Product Discontinuation

PDN-IFC-562-2017

Business Unit	Product Line Code	Type of Change	Action	Date of Issue
IFC - Industrial Field Connectivity	BF7	Product Discontinuation	Notify Distributors and Field	5/9/2017

Previous Product	New Product

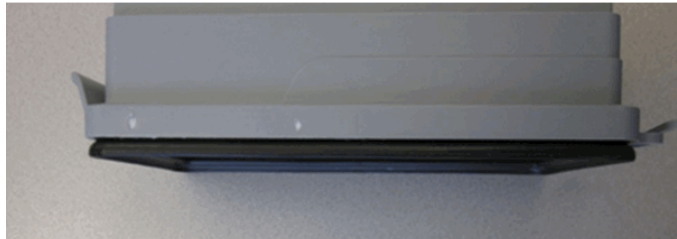
The shape of the gasket has been improved to enhance its performance and increase its protection rating from IP65 to IP66. This was accomplished by increasing its size and making it more durable with regards to deformation.
